ADDENDUM NO. 1

Schertz Seguin Local Government Corporation

Contract 3 - 36" Pipeline

October 27, 2020

DRAWING NO. **C174**

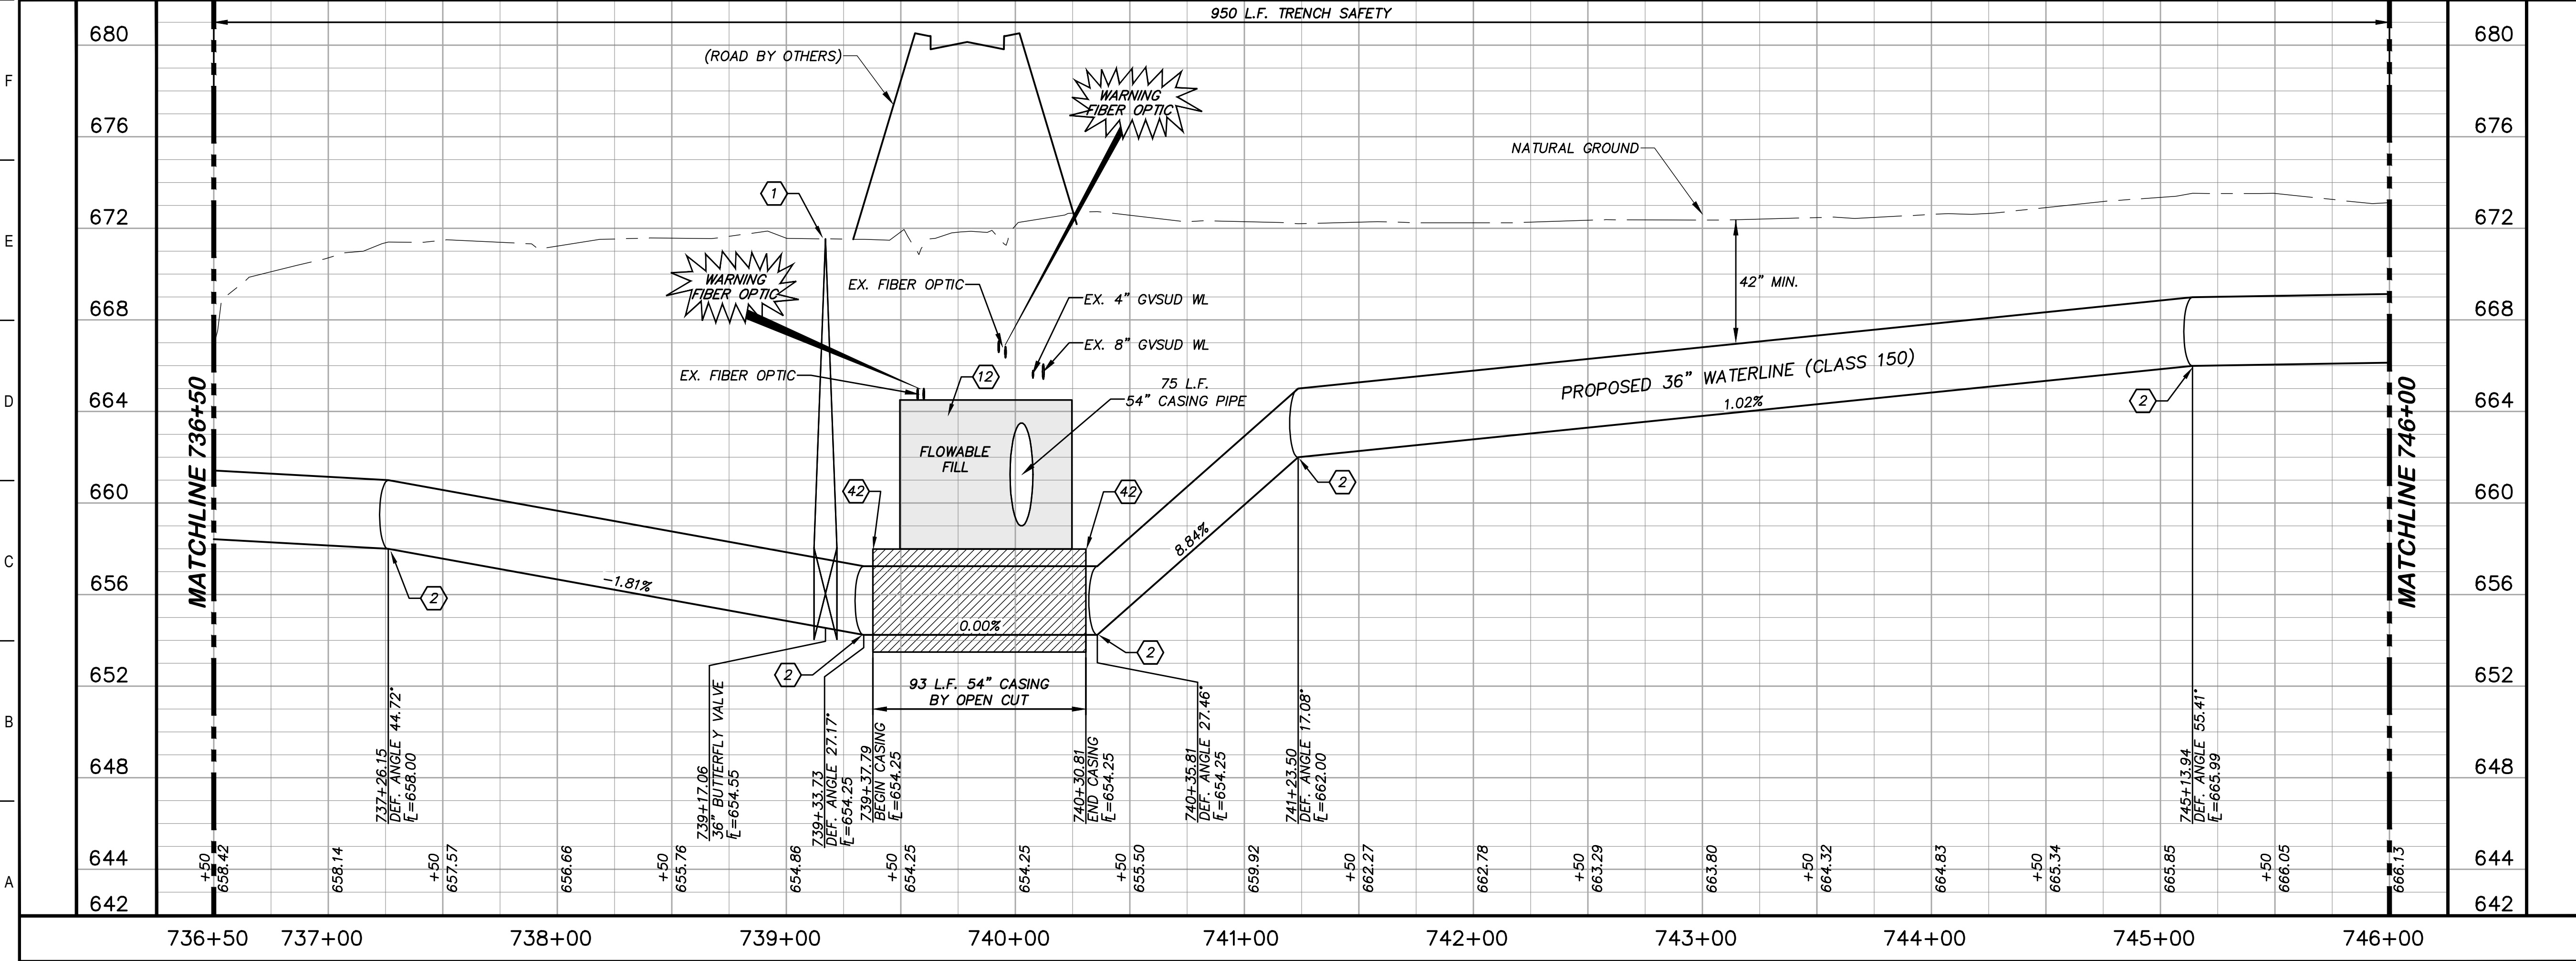
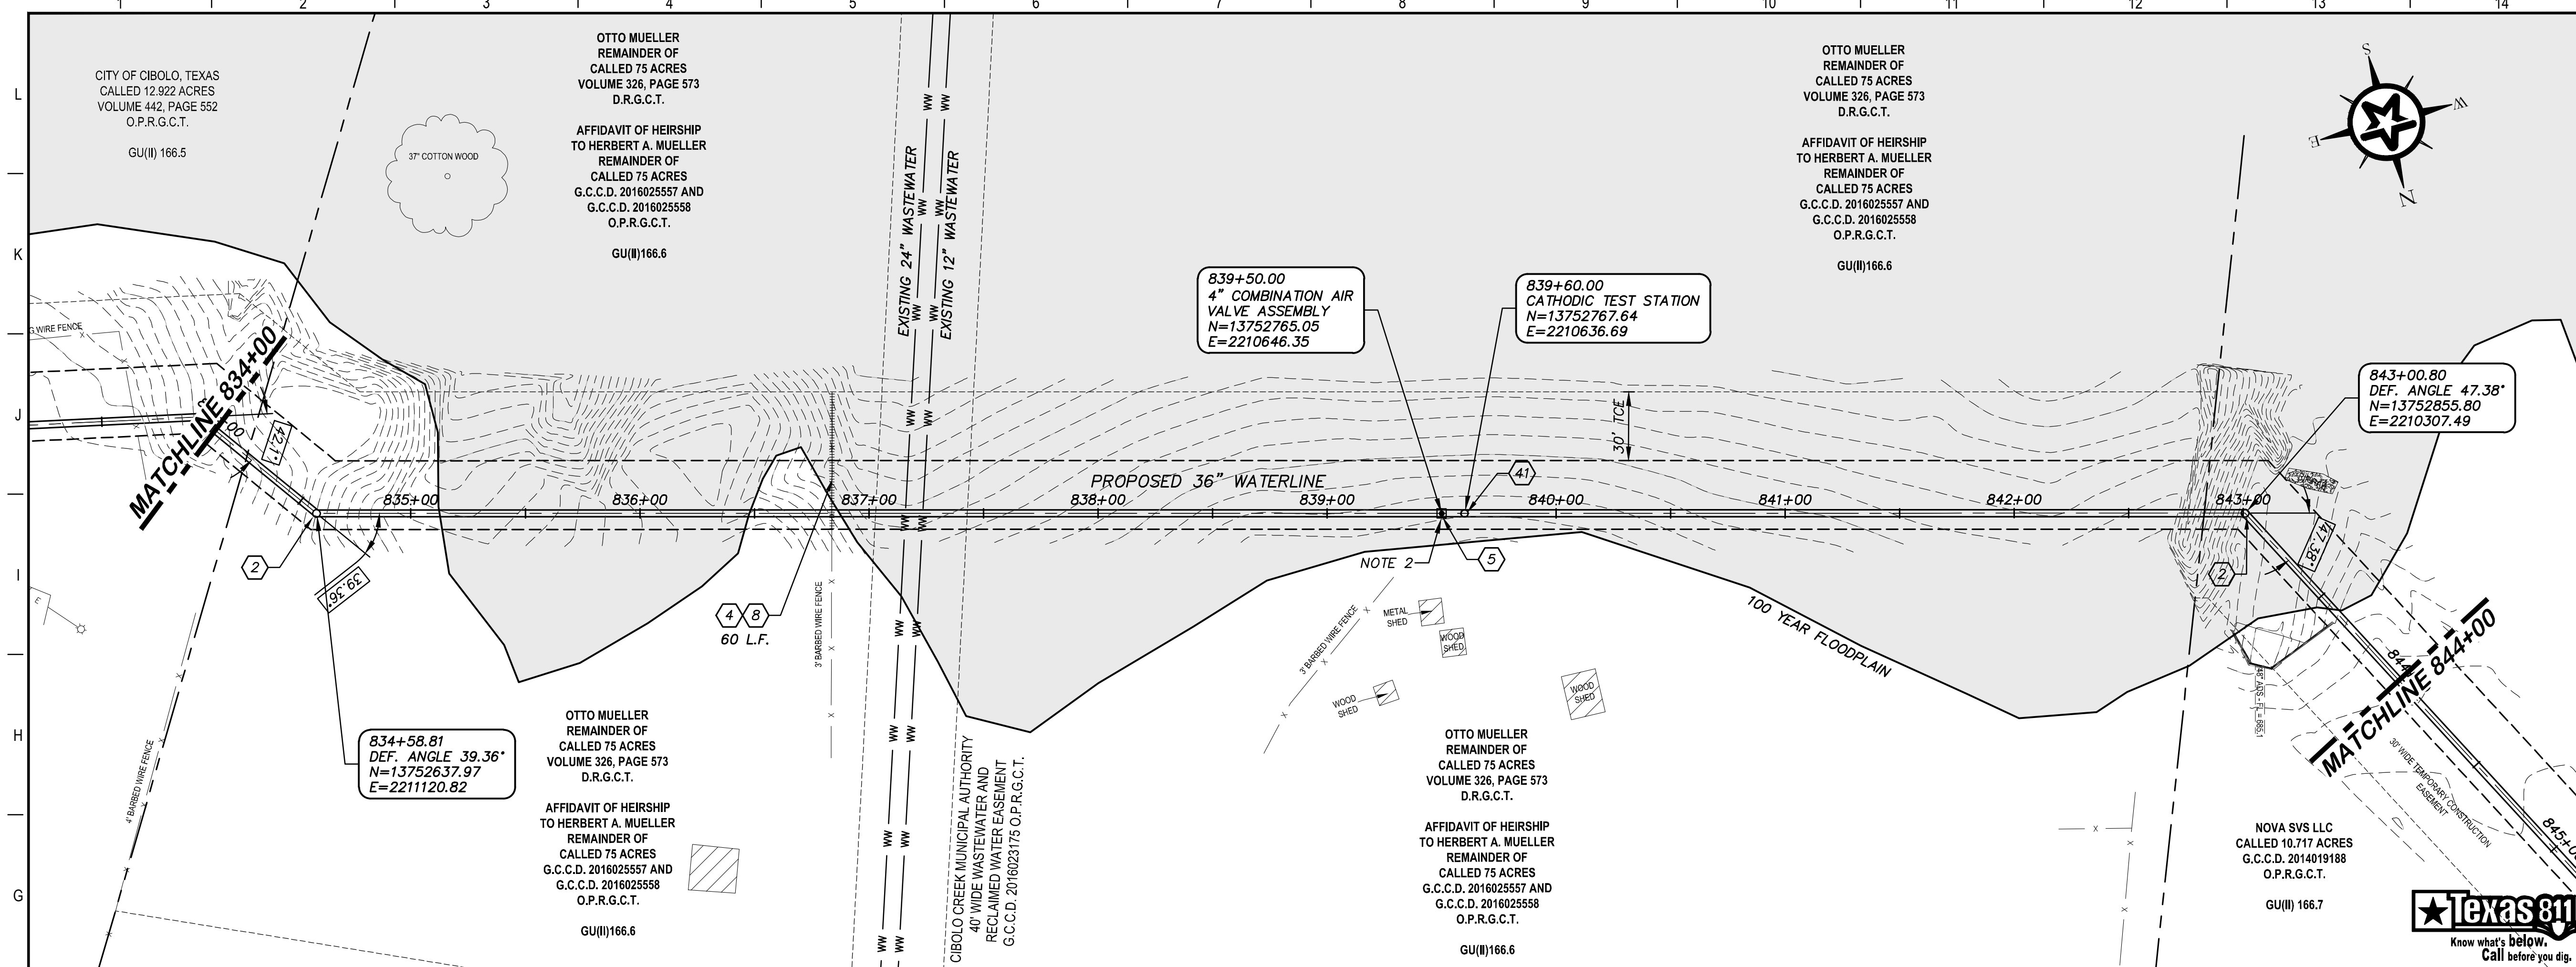
7. Sheet C174. Pavement Replacement added.
8. Sheet C184. Profile of pipeline is amended to accommodate the Air Valve Assembly. Use the attached sheet for this Project.

F8 4" COMBINATION AIR VALVE ASSEMBLY SECTION

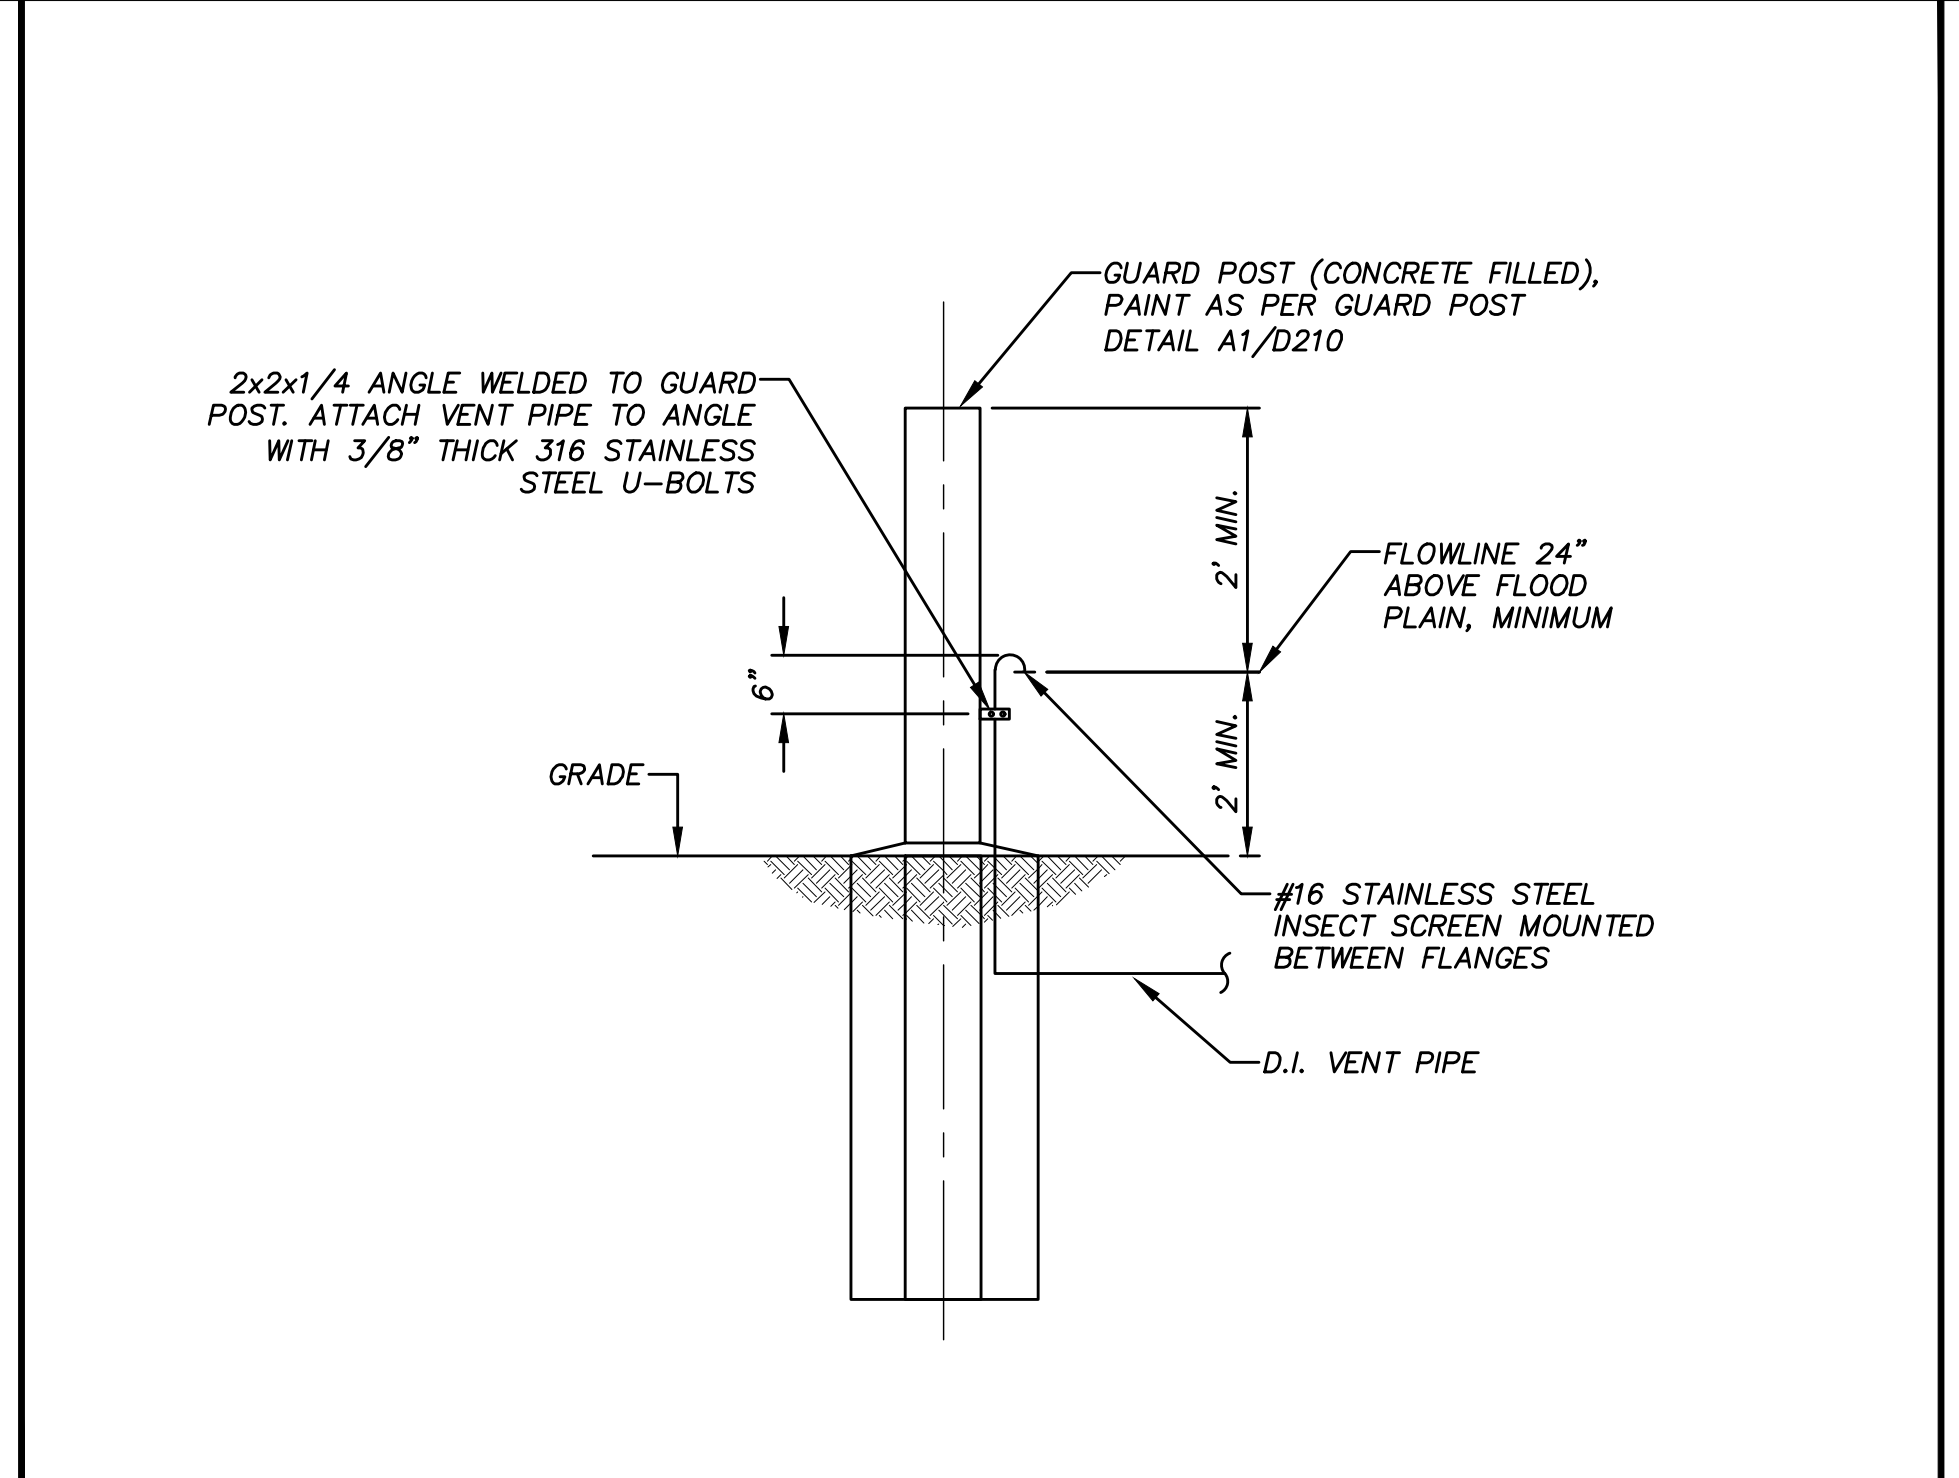
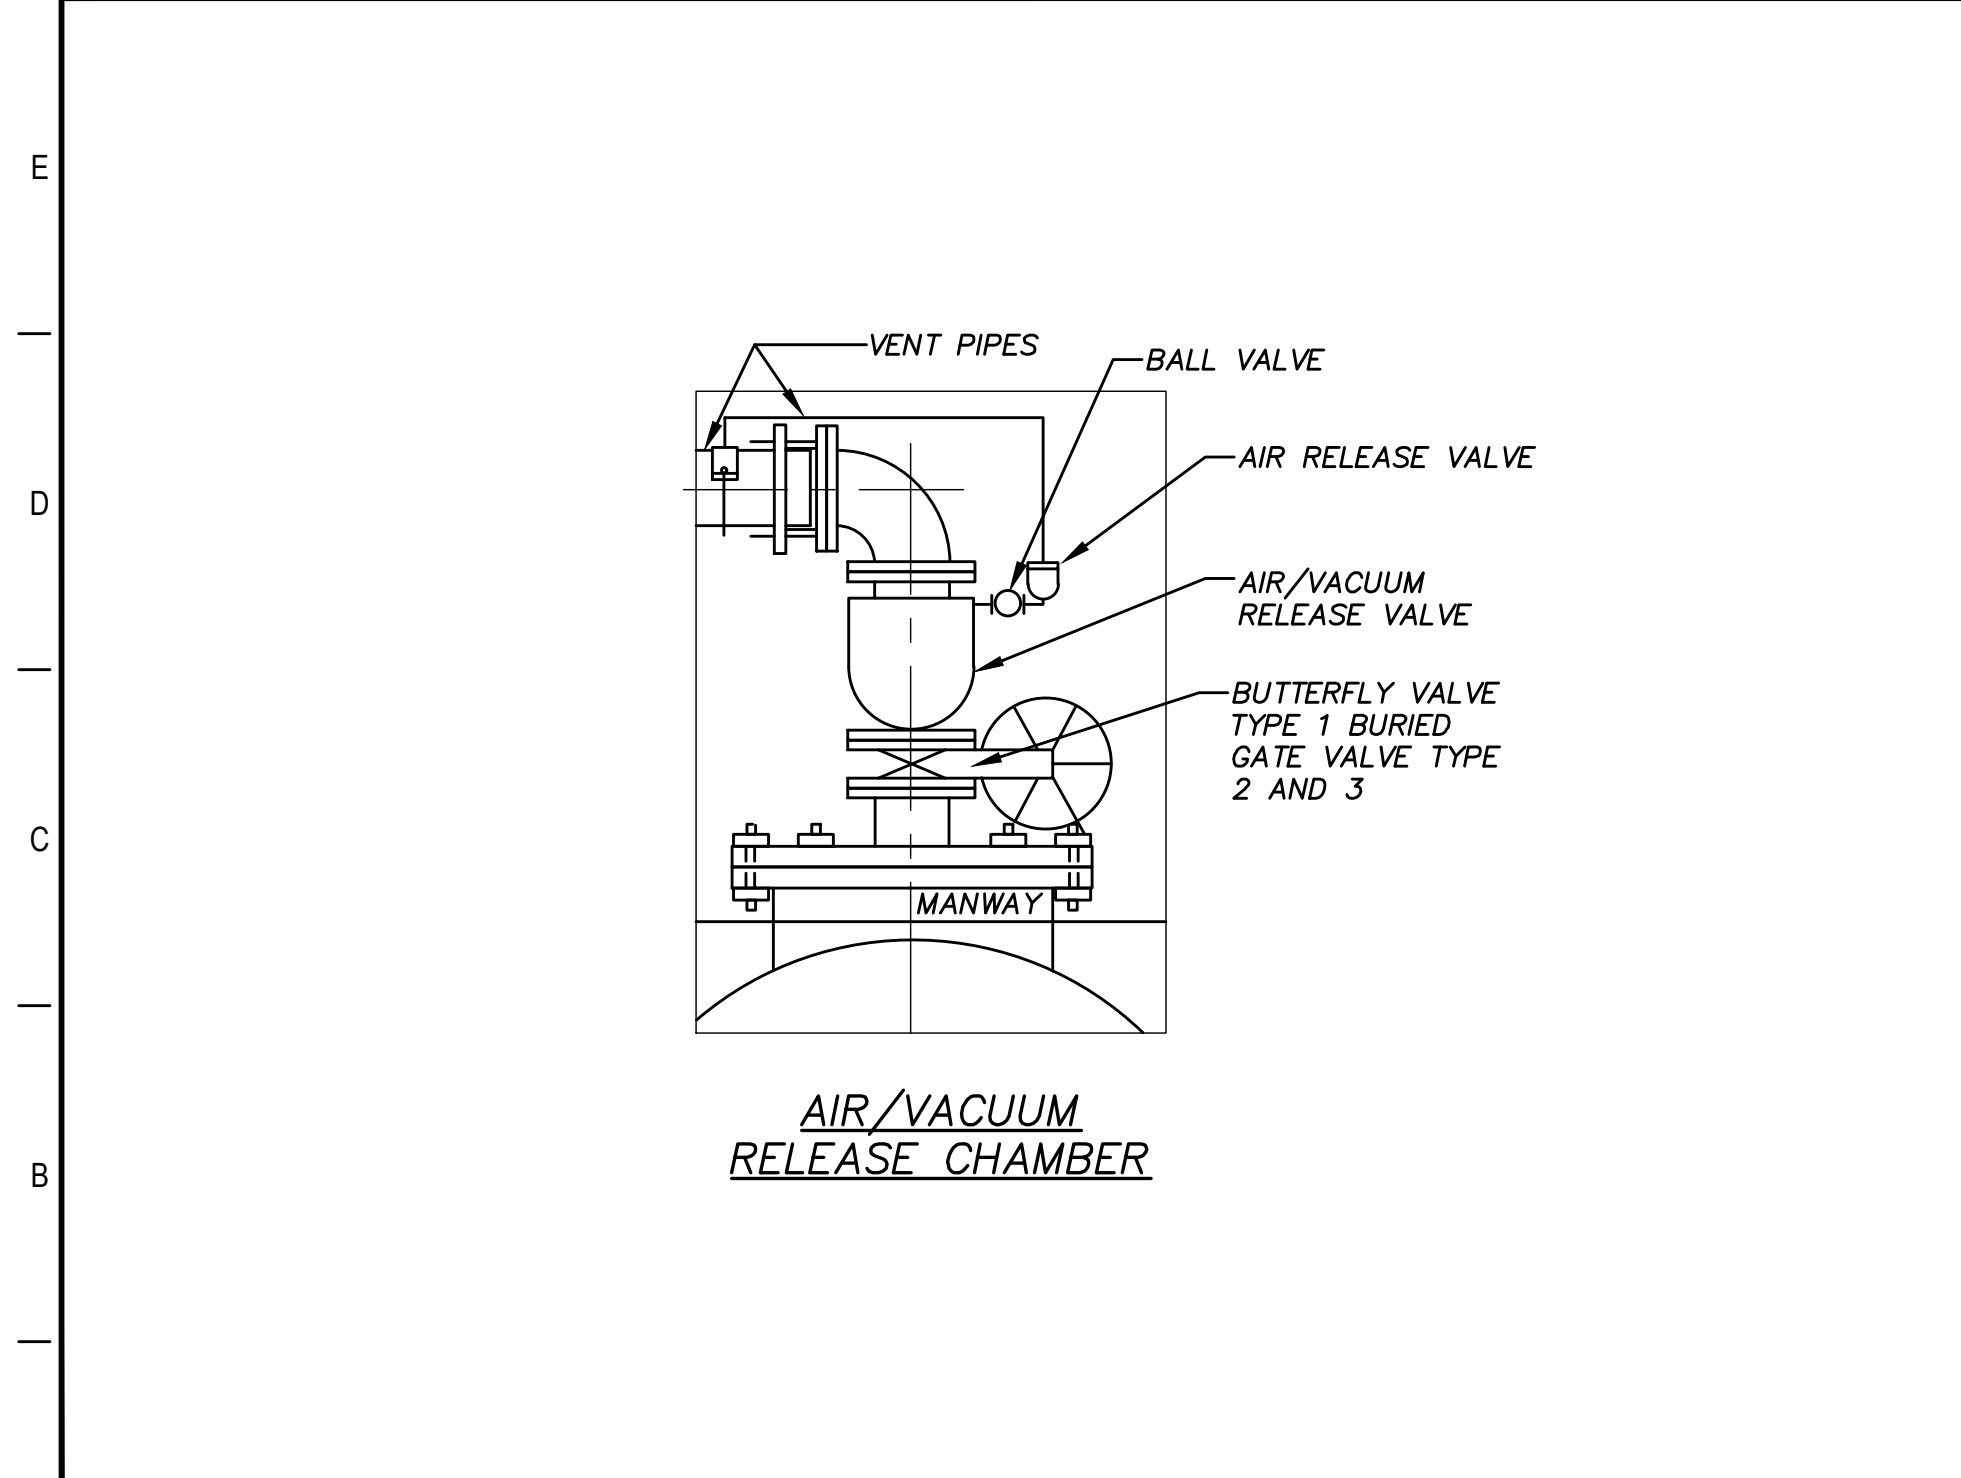
9. Sheet D201. 4” Assembly Combination Air Valve Detail (Item 27 of the Proposal Form) is hereby amended. Use the attached detail for this Project.
10. Sheet D301. Butt Strap added to Detail A1.
